**MONTGOMERY COUNTY HISTORIC PRESERVATION COMMISSION**  
**STAFF REPORT**

<b>Address:</b>	2420 Spencerville Rd., Spencerville	<b>Meeting Date:</b>	3/26/2025
<b>Resource:</b>	Master Plan Site #15/55 <b>Spencer-Carr House</b>	<b>Report Date:</b>	3/19/2025
<b>Applicant:</b>	Cedar Ridge Community Church (Ginger Donohue, Agent)	<b>Public Notice:</b>	3/12/2025
<b>Review:</b>	HAWP	<b>Staff:</b>	Dan Bruechert
<b>Permit Number:</b>	1107038	<b>Tax Credit:</b>	n/a
<b>Proposal:</b>	Silo Demolition

Figure 1: The designated parcel for the Spencer-Carr House. The star marks the approximate location silo proposed for demolition.

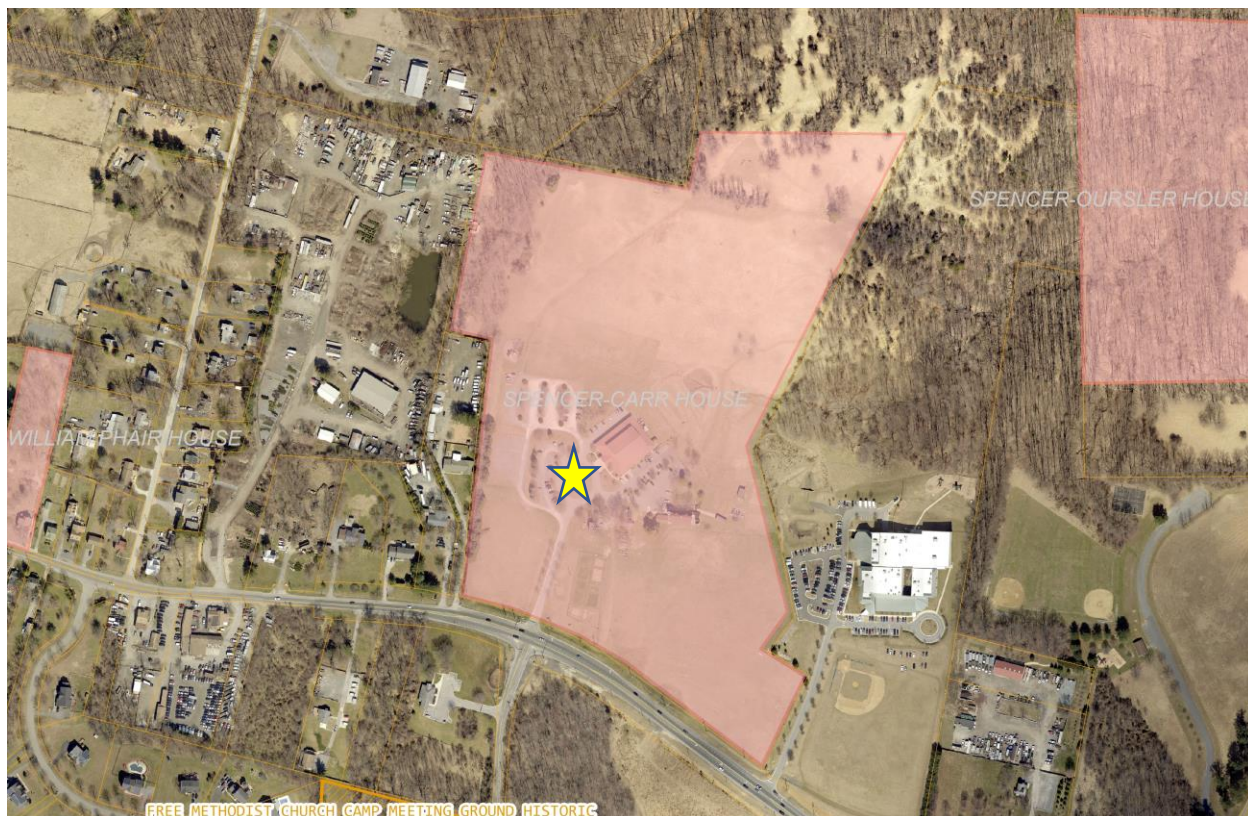
The applicant proposes to demolish a terra cotta and brick silo on the site.

*Figure 2: Detail aerial of the Spencer-Carr House site (historic house circled in yellow) with the silo circled in red.*

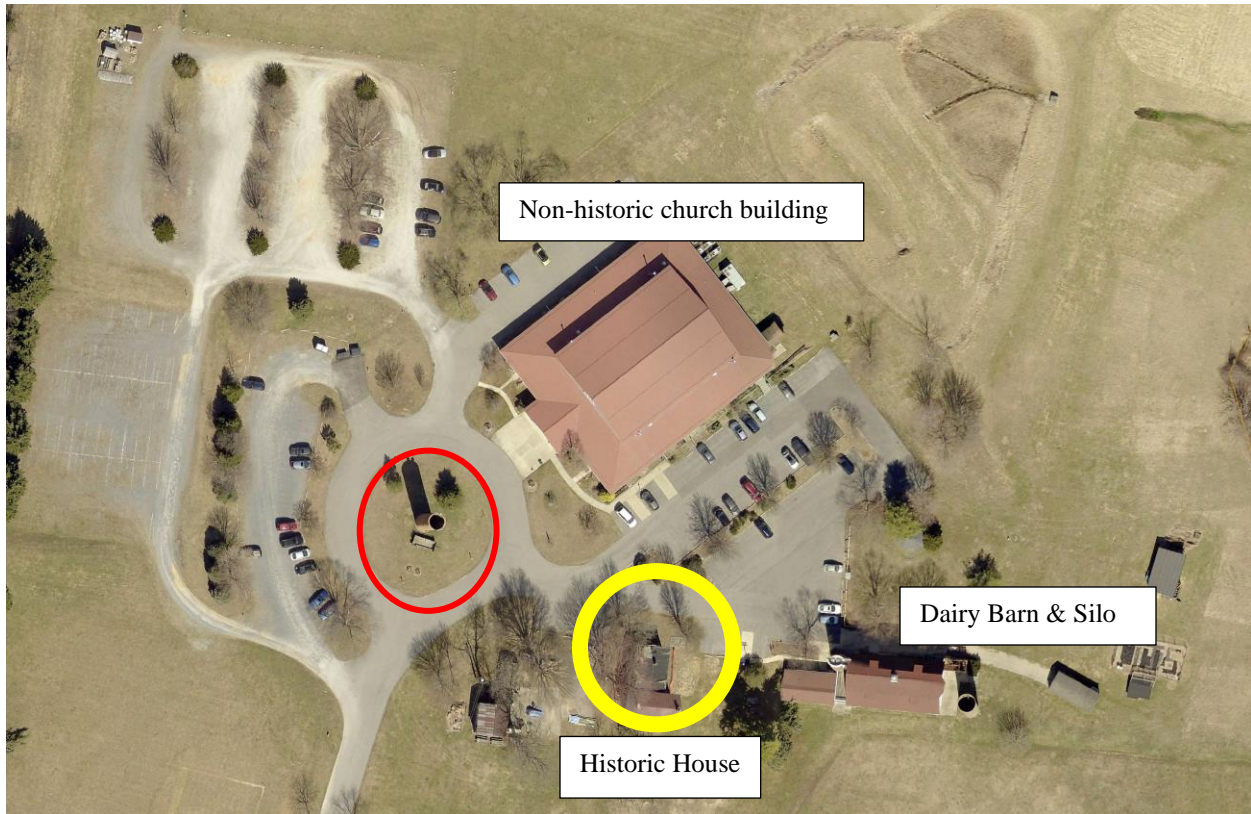
The applicant proposes to demolish the existing silo, located in front of the contemporary church serving as the central focus of a traffic circle (see Figure 2, above). The existing silo was constructed using terra cotta blocks, with a brick exterior. Staff's 1996 file photos from the designation of the Spencer-Carr House Master Plan Site show the location and treatment of the silo have not changed in nearly forty years (see Figure 3, below). The 1996 MIHP form identifies the silo as a "brick silo, west of the house, between the cottage and the shed." Staff's cursory research suggests this silo was constructed sometime from c.1910 when the hollow-tiled 'Iowa Silo' became widely adopted to c.1930 when all concrete silos became the norm.
